ARCHITECTURAL REVIEW COMMISSION MEETING AGENDA

ARCHITECTURAL REVIEW COMMISSION STAFF REPORT

New Drive-Thru Soda Shop: 2029 E. Fort Union Blvd.

Exterior Alterations: 1399 E. Fort Union Blvd.

Zoning Ordinance

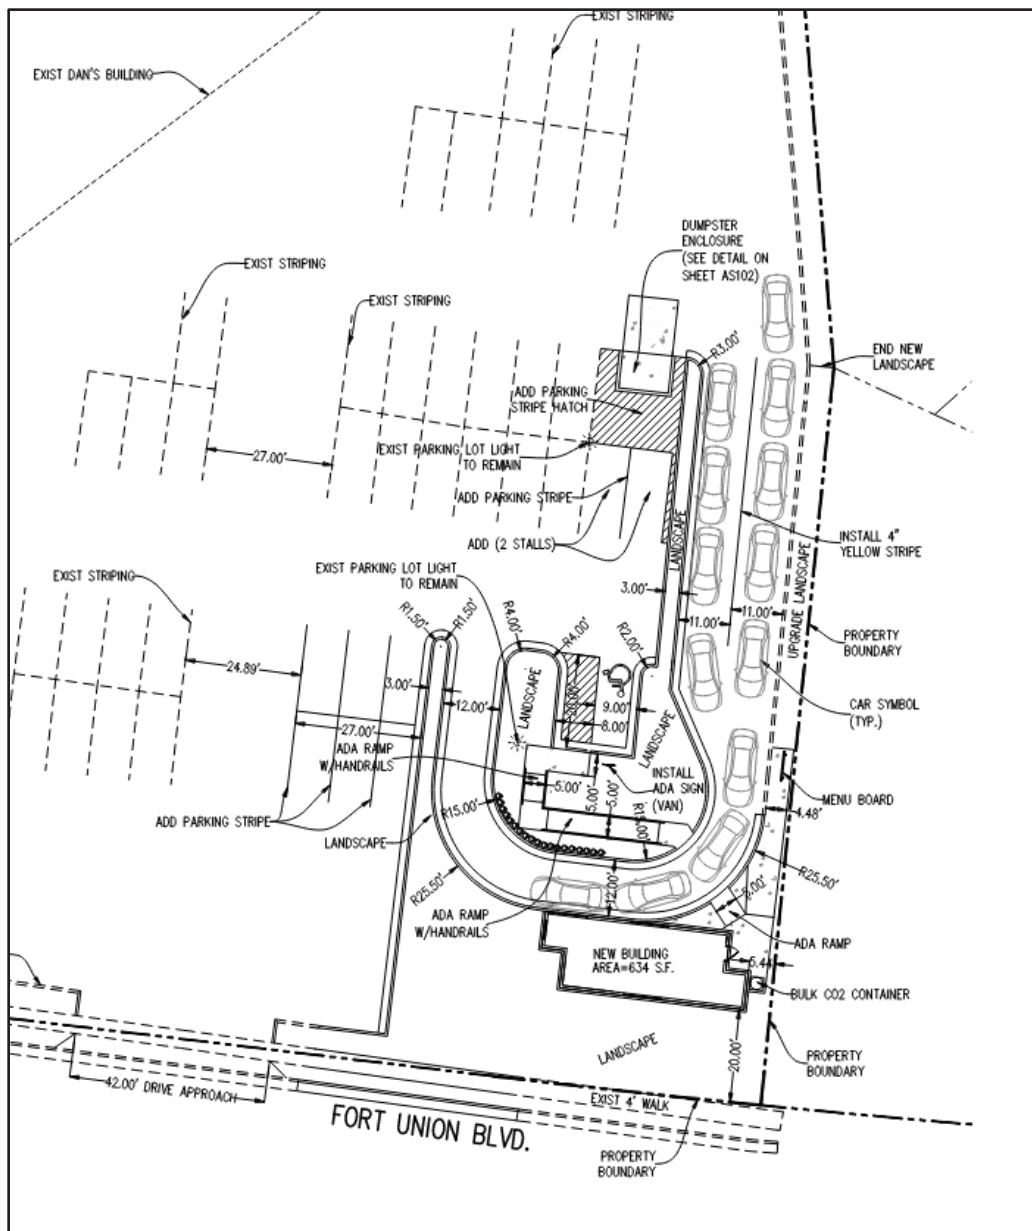
Lighting Requirements		
	Required	Provided
Point Illumination	< 10 foot candles	71.5 foot candles at menu board

Screening Requirements		
	Required	Provided
Dumpster Enclosure	50' from residential	34' from residential
Roof Appurtenances	Within enclosure	4' – 6' Steel enclosure

Staff Analysis: The application must be revised to meet the code requirements for site illumination and dumpster enclosures. These technical corrections will be resolved administratively prior to building permit issuance. The project has been designed to meet all other relevant requirements of the CR (Regional Commercial) zone. Any development in the CR zone requires a master development plan to be approved by the Planning Commission. This project has been scheduled for Planning Commission consideration on May 5, 2021.

Site Plan & Parking Plan*Proposed Site Plan*

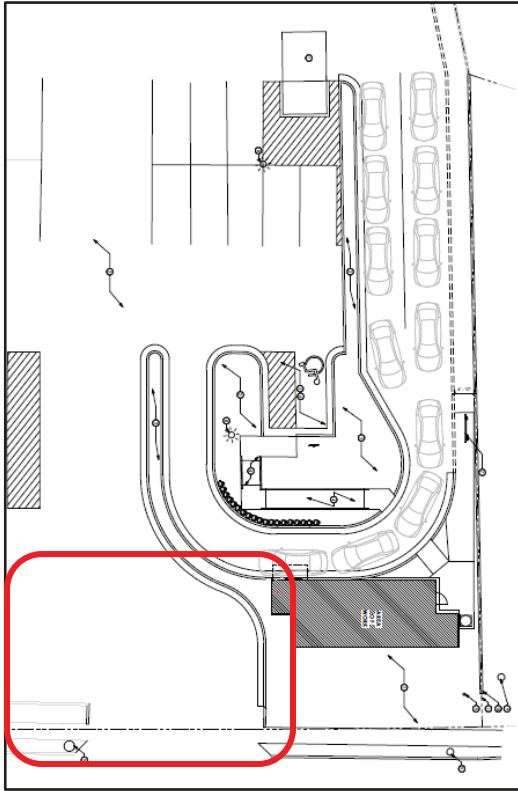
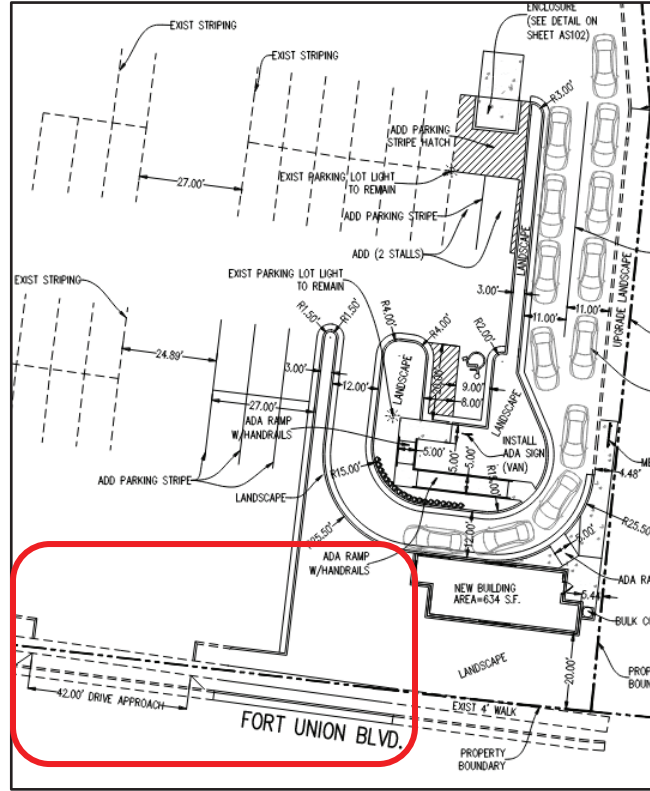
- Traffic study recommendations
 - Relocate the Fort Union access to align with Ponderosa Drive.
 - An analysis of 4 existing Swig locations in Salt Lake County found that the average peak drive-thru queue was 13 vehicles. The highest observed queue was 16 vehicles.

Staff Analysis: A traffic impact study has been submitted for this project which recommends relocating the existing drive approach and providing a queue that can accommodate 13 vehicles, with overflow capacity for up to 16 vehicles. The proposed site plan incorporates both recommendations, with a layout that prevents conflict near the Fort Union access point and keeps the overflow in the parking lot area.

Proposed Landscaping Plan

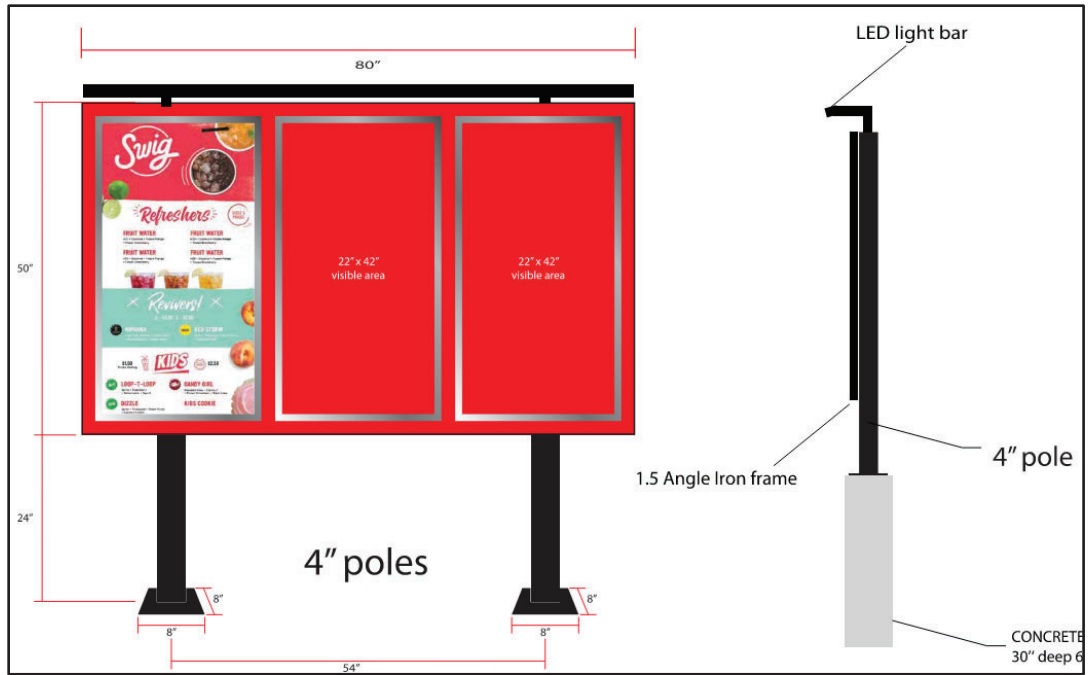
Staff Analysis: The front yard area of properties in the CR zone is required to be landscaped and maintained with live plant material including shrubs, flowers, and trees. This application includes a landscaping plan that meets the minimum requirements of the zoning ordinance. Water-efficient trees and landscaping are highly encouraged in all situations.

Proposed Menu Sign with LED Light Bar

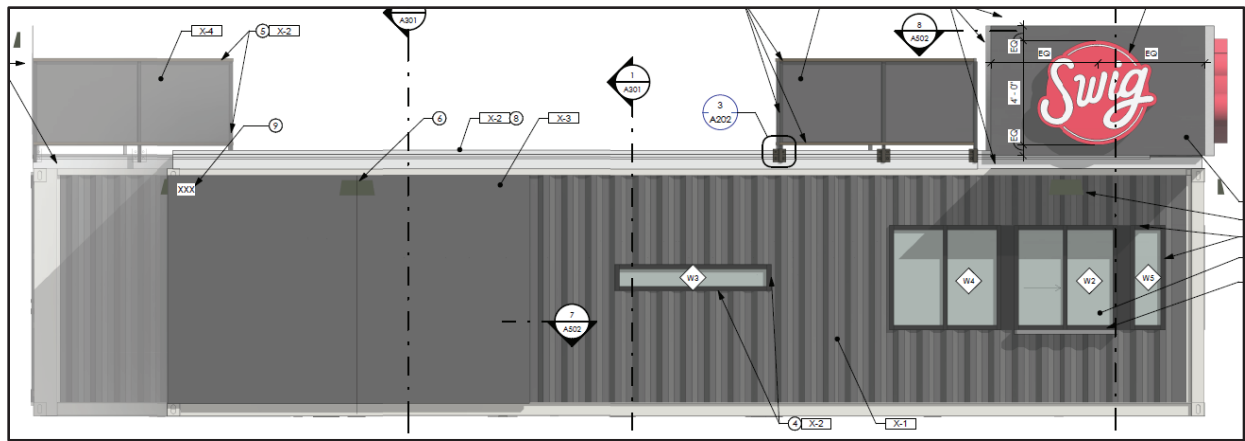
Staff Analysis: City ordinance requires that the LED light bar above the menu board sign be revised for compliance with the outdoor lighting code (No point on the property shall be illuminated greater than 10.0 foot-candles).

Site Plan

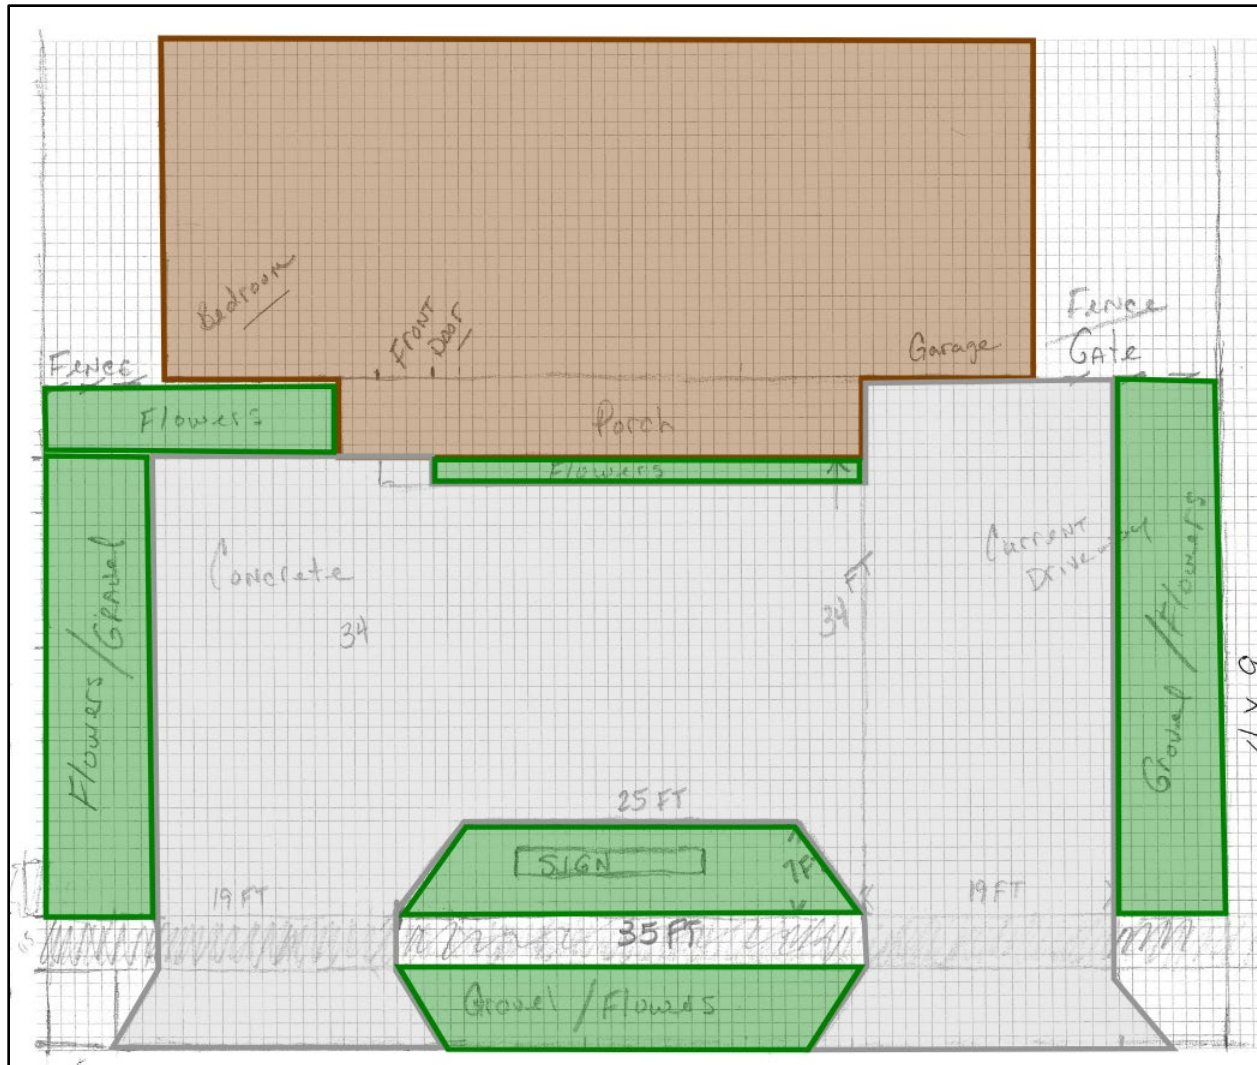
Staff Analysis: Staff recommends the ARC discuss appropriate landscaping standards for the new landscape areas on the site plan. The applicant should submit a revised site landscaping plan with appropriate detail that incorporates the ARC's recommendations prior to final approval.

1. Prior to final approval the applicant shall submit a site/landscaping plan with appropriate detail that incorporates the ARC's recommendations and confirms that the driveway is code compliant.
